APPLICATION NO.	FILING DATE	FIRST NAMED INVENTOR	ATTORNEY DOCKET NO.	CONFIRMATION NO.
10/561,927	12/22/2005	Masataka Ohta	2005-1724A	3211
513 7590 03/23/2009 WENDEROTH, LIND & PONACK, L.L.P. 1030 15th Street, N.W., Suite 400 East Washington, DC 20005-1503				
EXAMINER				
WONGWIAN, PHUTTHIWAT				
ART UNIT		PAPER NUMBER		
3741				
MAIL DATE		DELIVERY MODE		
03/23/2009		PAPER

Office Action Summary

DETAILED ACTION

FIG. 2

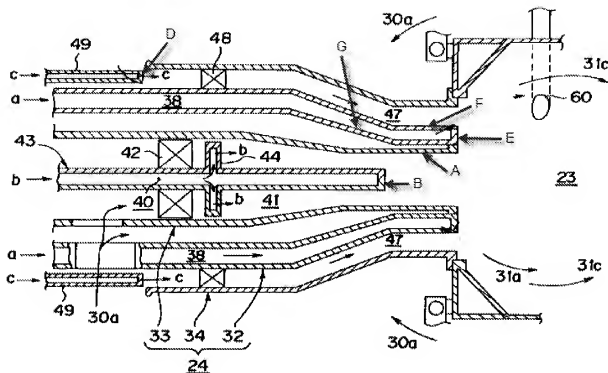
16. Claims 16 and 17 are rejected under 35 U.S.C. 102(b) as being anticipated by Iwai (US Patent No. 6,070,411).

17. As to claims 16 and 17, Iwai discloses a combustor 20 (fig. 1) comprising: a pilot nozzle 43 (fig. 2) being provided in a center portion (fig. 1) of a combustor main body 22 (fig. 1); a plurality of main nozzles 49 (fig. 2) being provided in a surrounding area of the pilot nozzle at regular intervals; a pilot cone A (fig. 2 above, when the angle is 0 degree) covering a downstream-side tip portion B (fig. 2 above) where a fuel b (fig. 2) of the pilot

nozzle flows; and main burners 47 (fig. 2) covering downstream-side tip portions D (fig. 2 above) of the main nozzles 49 (fig. 2); and wherein, the pilot cone comprises: a tapered portion A (fig. 2 above) of inner circumference of the cone A (fig. 2 above, when the angle is 0 degree) being formed in a tapered shape so as to stretch out in a radial pattern toward a downstream side; and a collar portion E (fig. 2 above) which is provided to an external periphery of a downstream-side tip E (fig. 2 above) of the tapered portion of inner circumference of a cone and serves as [intended use] a surface being approximately vertical to axial direction of the said pilot nozzle; and wherein, an angle (any angle, inherent) in axial direction to a line (any line) connecting an external periphery of a downstream-side tip of the pilot nozzle and an external periphery of downstream-side tips of the main burners is specified as " α ," an opening angle of the tapered portion of inner circumference of a cone " θ " is " $0 \leq \theta \leq 2\alpha$." (when the angle is 0 degree) wherein, an outer circumference F (fig. 2 above) of the tapered portion of inner circumference of a cone is provided with a cylinder (fig. 1-2) being shaped so as to be along an outer wall G (fig. 2 above) of the tapered portion A (fig. 2 above) of inner circumference of the cone and the collar portion.
